TOWNHOMES @
MASON'S LANDING
GRADING AND
DRAINAGE PLAN
Rio Grande
Engineering
1808 CENTRAL AVENUE SE
SUITE 201
ALBUQUERQUE, NM 87108
(505) 672-0699

HAND WRITTEN NOTES ON THIS AS BUILT

AS BUILT

SECTION E-E

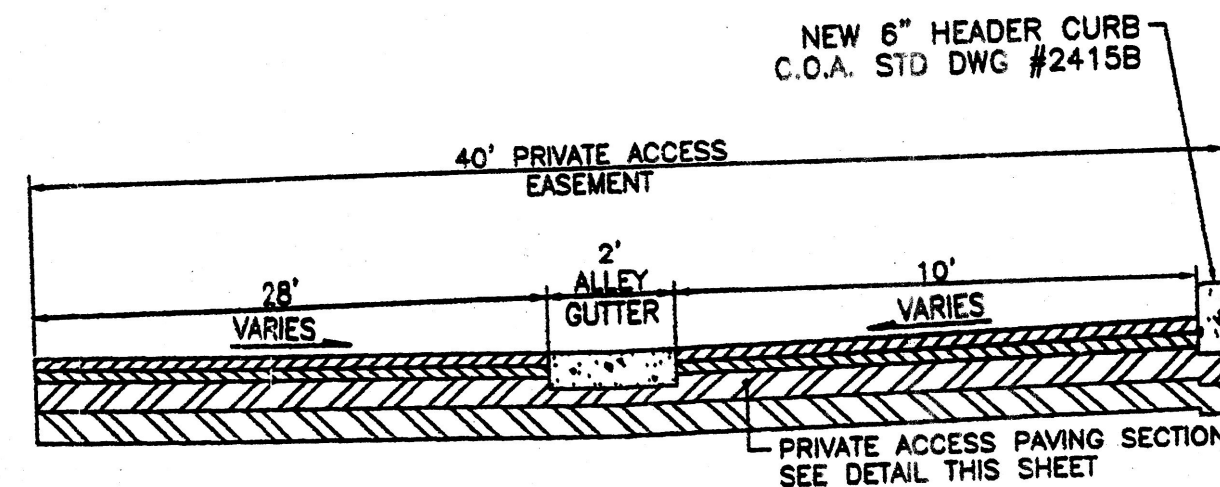
SEE ATTACHED DETAIL
E-E FROM RIO GRANDE ENG.
PERMIT DRAWINGS

ENGINEER'S SEAL 	TOWNHOMES @ MASON'S LANDING GRADING AND DRAINAGE PLAN <i>Rio Grande Engineering</i> 1006 CENTRAL AVENUE SE SUITE 201 ALBUQUERQUE, NM 87106 (755) 572-0939	DRAWN BY: WCWJ DATE: 2-24-05 2448-GRB-1-13-05X SHEET # C-100 JOB # 2448
---------------------	---	---

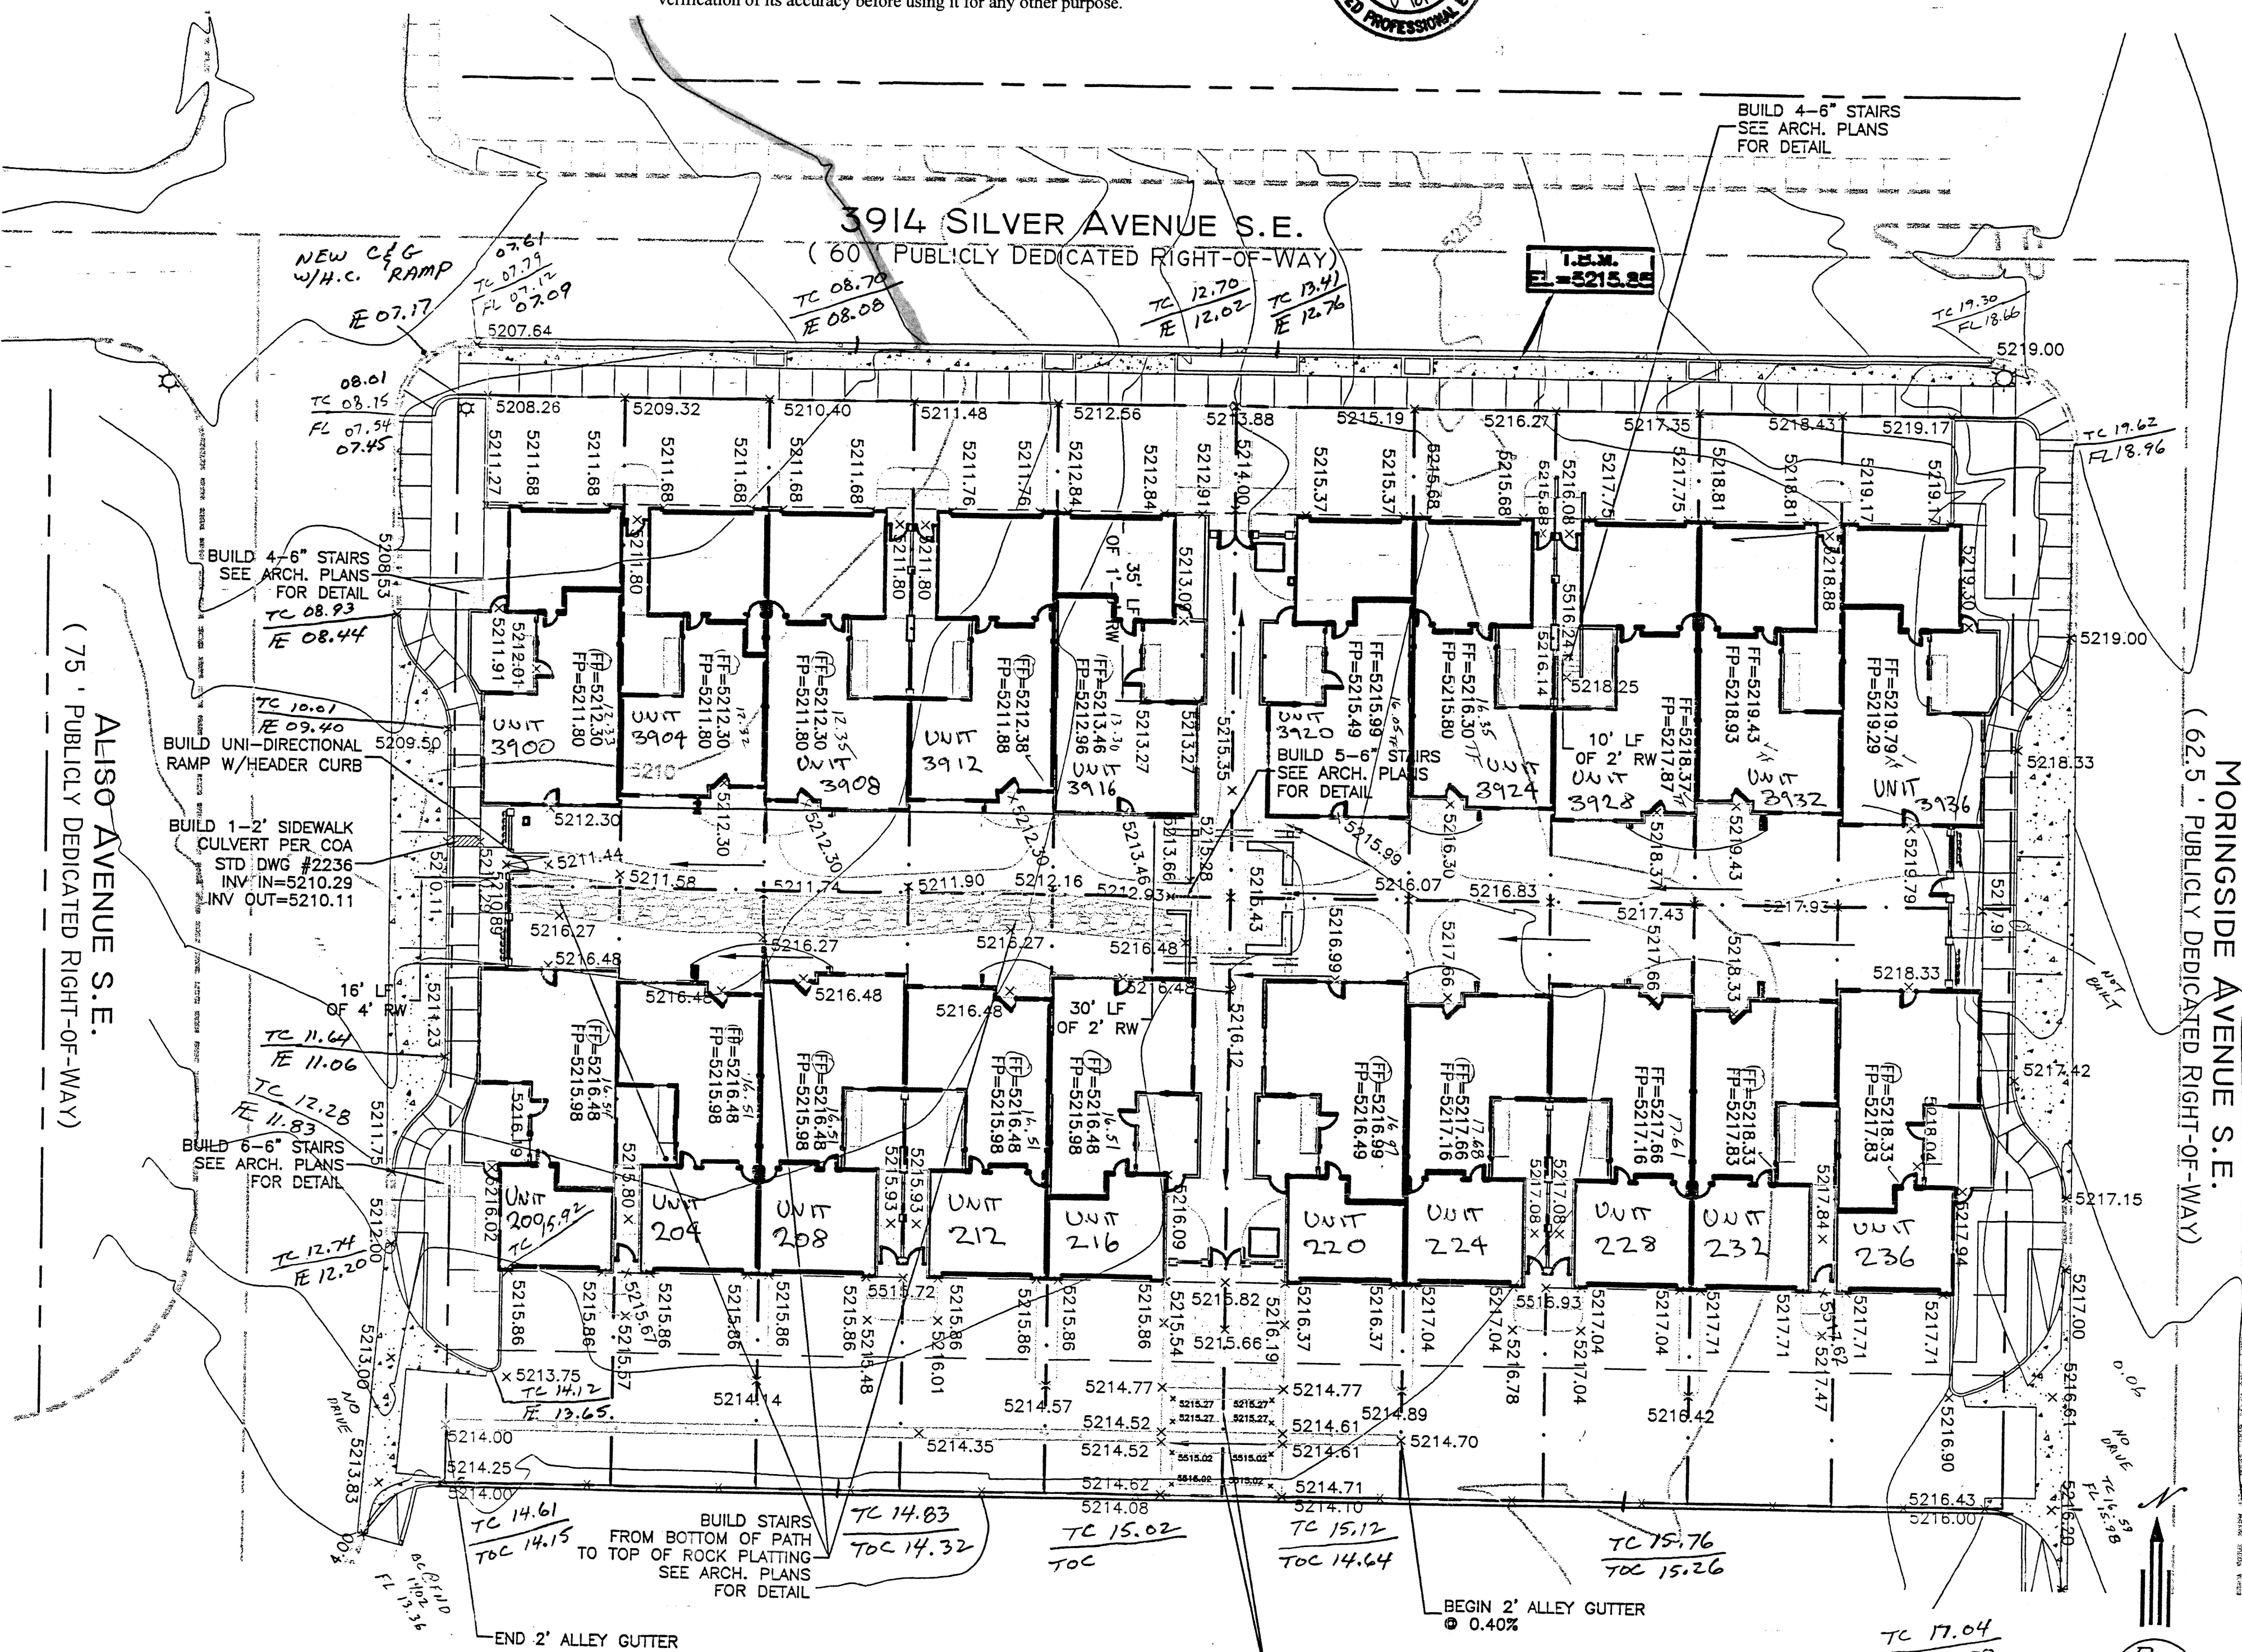
AS-BUILTS
CURBS
MR-BMC
1-12-06

NOTE: ON SOUTH
SIDE OF PROJECT
NO ASPHALT HAS
BEEN INSTALLED

BUILD RAISED ASPHALT SPEED HUMPS
CONTINUE 2' ALLEY THROUGH MIDDLE
OF HUMPS

TOC = TOP OF CONC
ON PARK SIDE OF
NEW CURB

TC = TOP OF CURB
